Harestanes South Windfarm Extension

Environmental Impact Assessment Report

Addendum
June 2022

**Harestanes South
Windfarm Extension**
Figure A1: Site Layout Plan

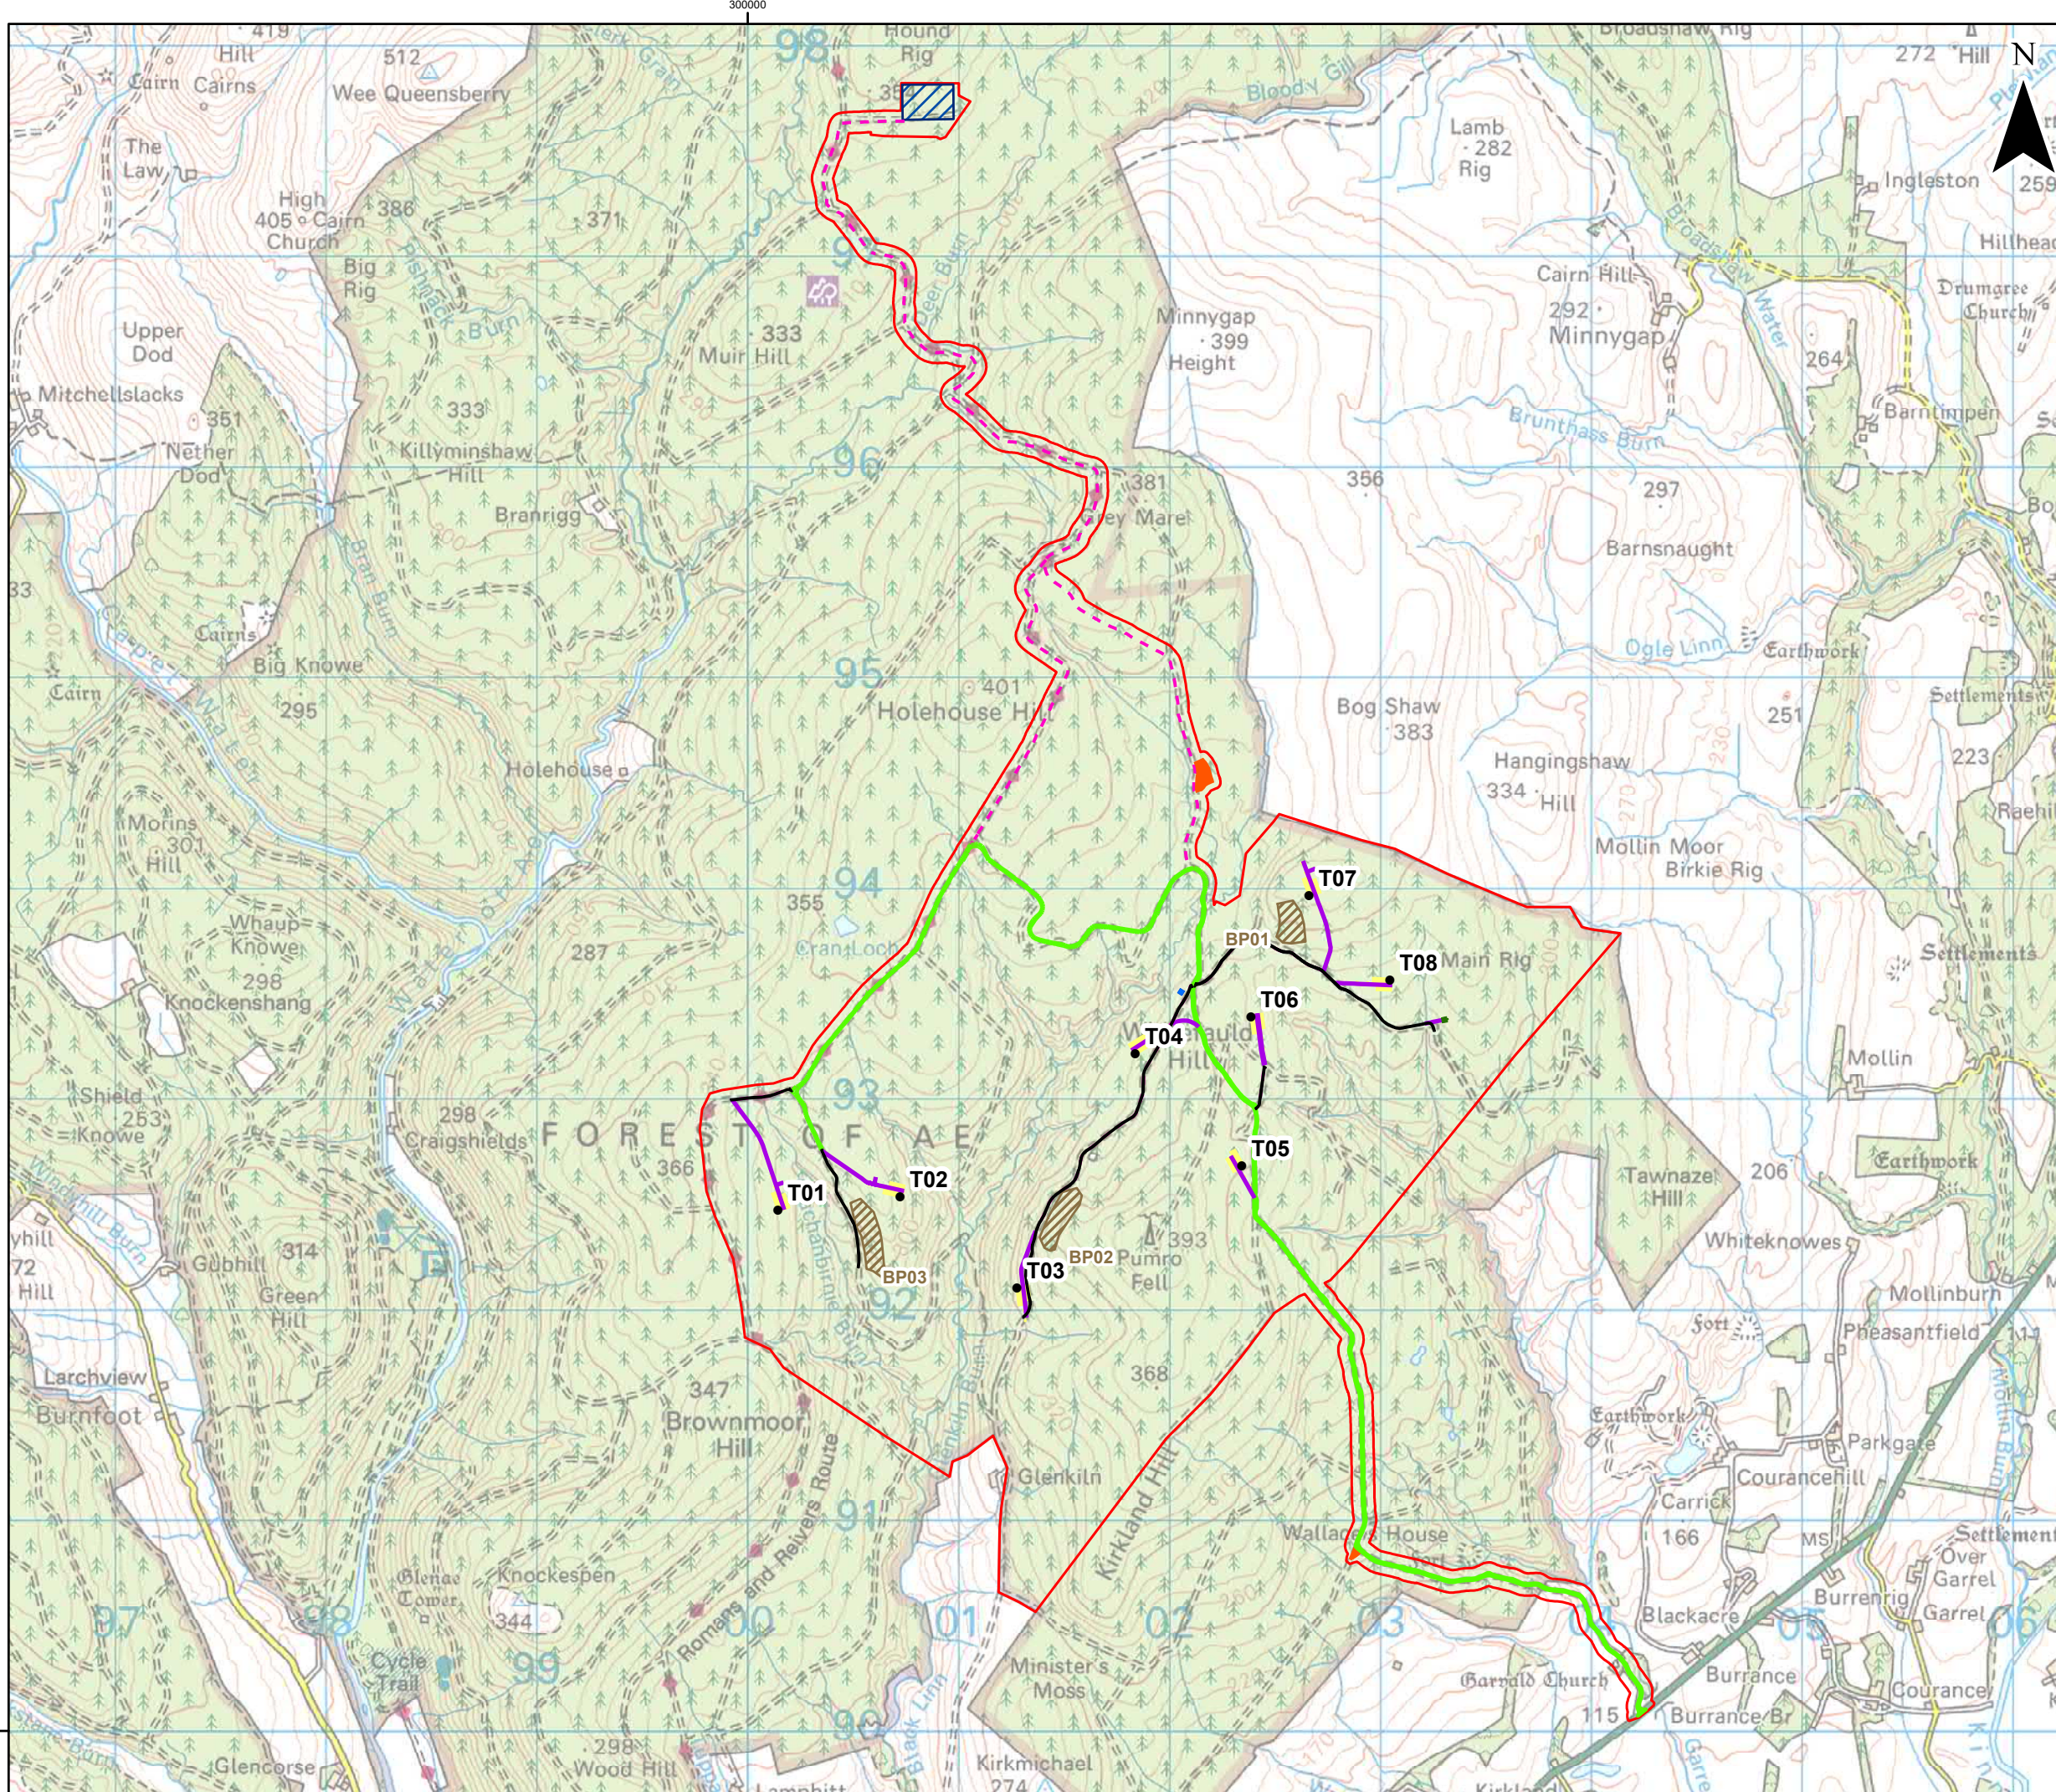
- 24. The original description of the Proposed Development is as detailed in Chapter 4 – Development Description of the EIA Report.
- 25. The change to the Proposed Development comprises a revision to the location of Turbine 06 approximately 64 m to the north west of its original position, see **Figures A1 Revised Site Layout Plan** and **A2 Design Iteration of Turbine 06**. The original and revised wind turbine coordinates are shown in **Table 3.1**.

Harestanes South Windfarm Extension
Figure A2: Design Iteration of Turbine 06

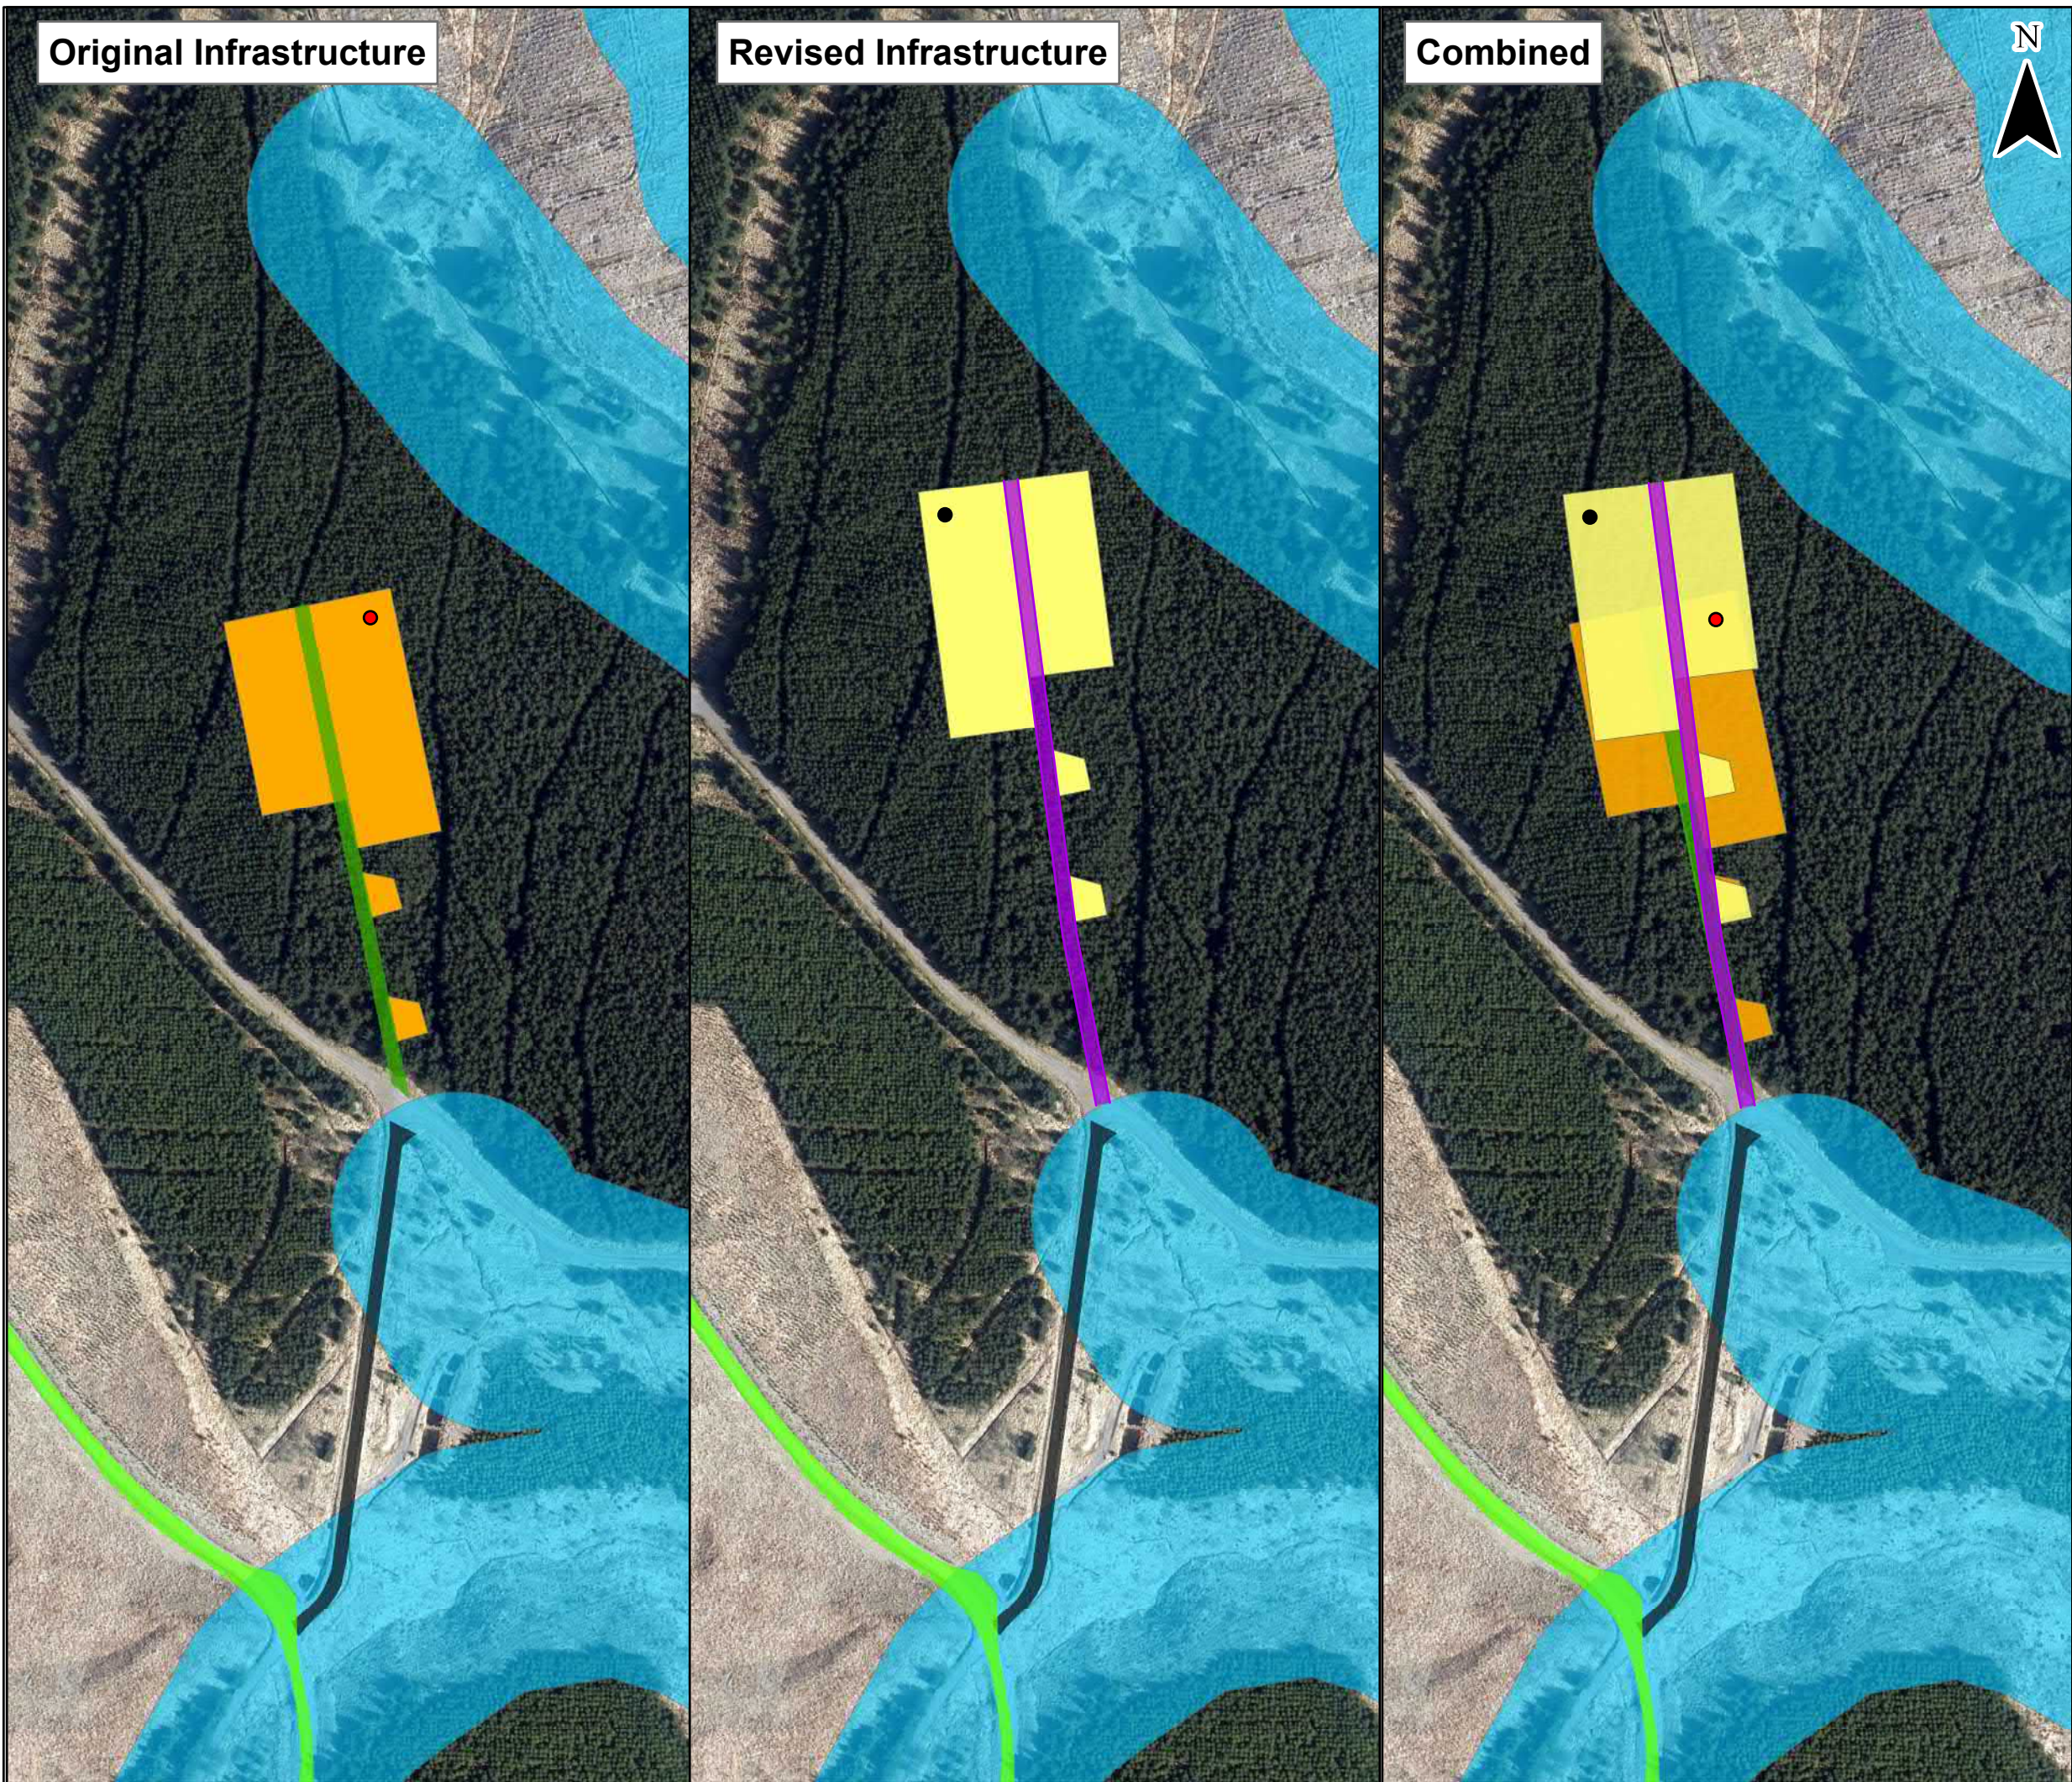
- 26. As a result of the change in turbine position, the track which accesses Turbine 06 has been realigned resulting in an increase in length of 58 m. **Table 3.2** shows the changes in values with respect to infrastructure parameters.

Turbine ID	Original Position Turbine 06		Revised Position Turbine 06	
	Easting	Northing	Easting	Northing
06	302440	593352	302390	593393
